RE: **Premier M.H Display Yard
Grading Plan
Engineer's Stamp Date 7/12/17
Hydrology File: M14D012C2**

Based on the information provided in the submittal received on 7/19/17 the above-referenced Grading Plan cannot be approved for Building Permit until the following are addressed:

LOT 1A-1, BROADWAY INDUSTRIAL CENTER, UNIT 2
ALBUQUERQUE, BERNILLO COUNTY, NEW MEXICO
2700 BROADWAY BLVD. SE
A PREMIER DEVELOPMENT
Site - Grading & Drainage Plan

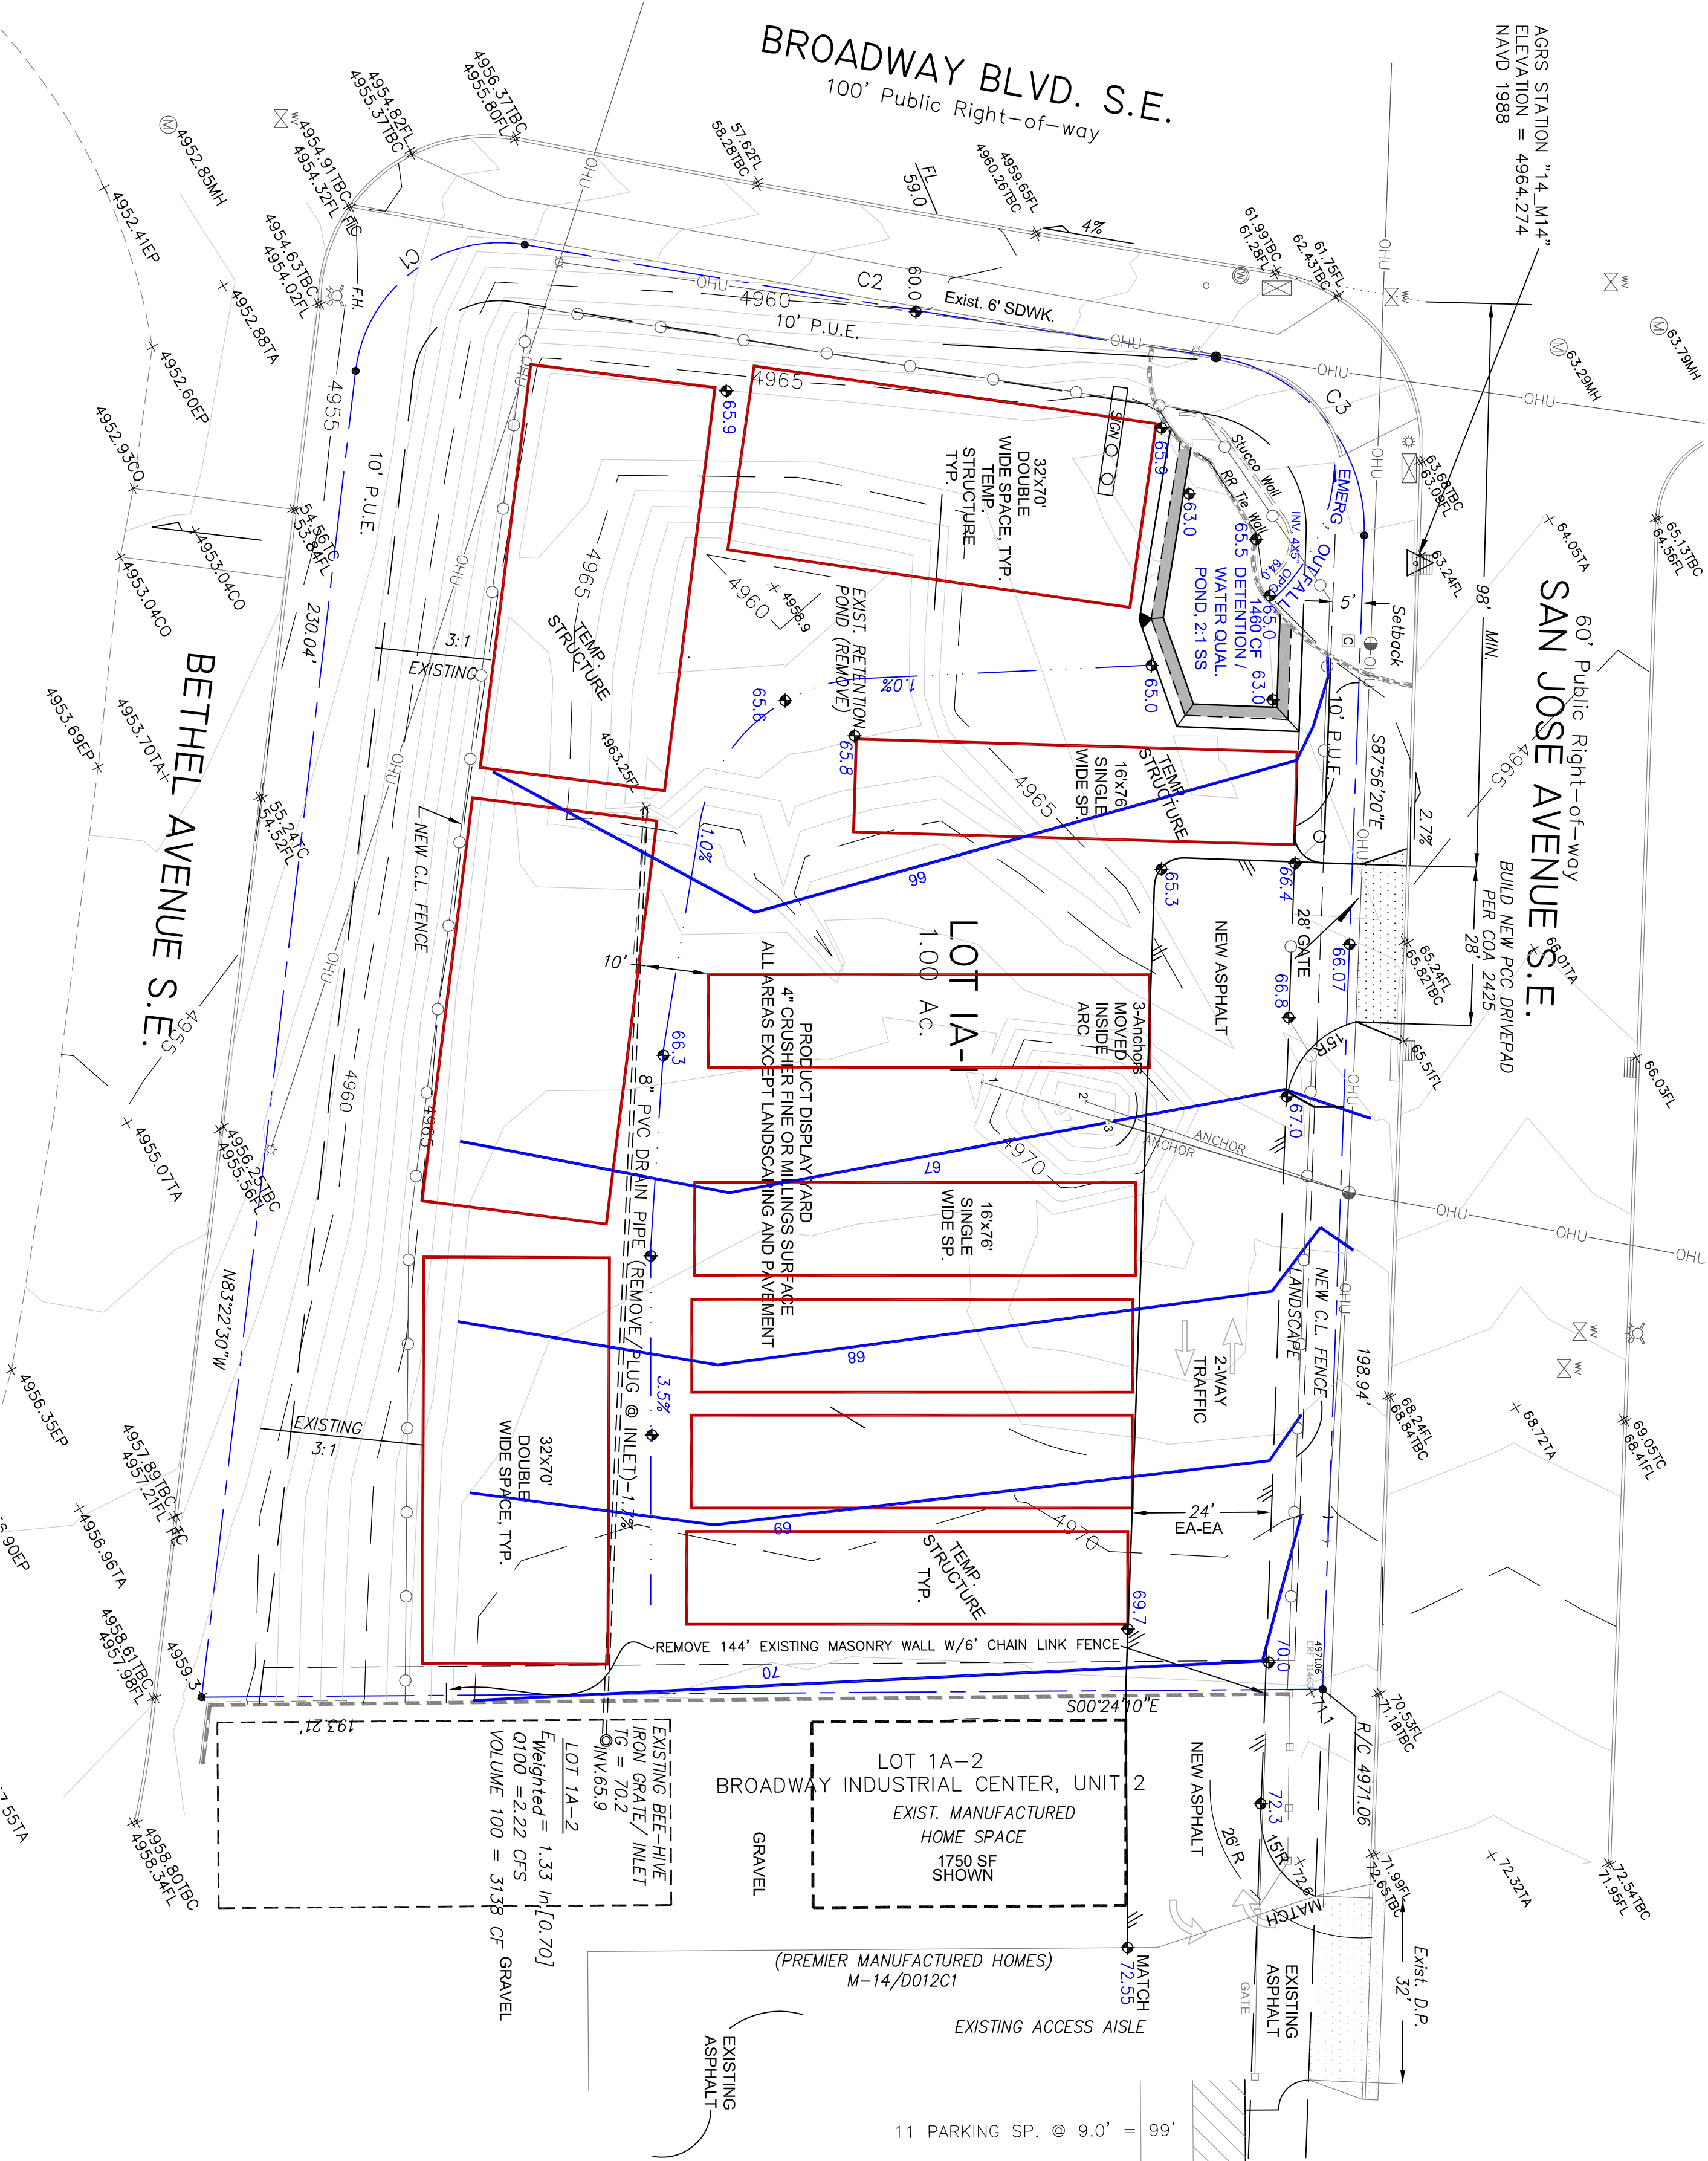
1. The 72" storm drain in Broadway, intended to alleviate flooding and allow free discharge from this site and other along Broadway, has not been constructed. The temporary retention pond on this site must remain in place until such time that the downstream system has capacity to allow for free discharge. Increased flows to over-capacity systems cannot be authorized by the City Engineer in accordance with § 14-5-2-12 (G) of the Albuquerque Code of Ordinances.

2. This project must include a plan for the retention of the 100-yr, 10-day runoff for developed flows from lots 1A-1 and 1A-2, unless downstream capacity can be proven.

3. Provide cross lot drainage and access easements for lots 1A-1 and 1A-2.
4. A private facility drainage covenant will be required for the new pond.
5. Written approval must be obtained from PNM to move their guy wires and work in their easement.

6. Written approval must be obtained from the owners of lot 1A-2 to remove their wall.
7. The new driveway entrance off San Jose cannot be placed over the transition slab for the existing inlet.

8. Extend the topography east to include the west side of lot 1A-2.
9. Provide detailed calculations for how impervious area (land treatment D) was determined. Also, this entire lot was previously graded; therefore no land treatment A remains.
10. An approved ESC Plan is required for this site.
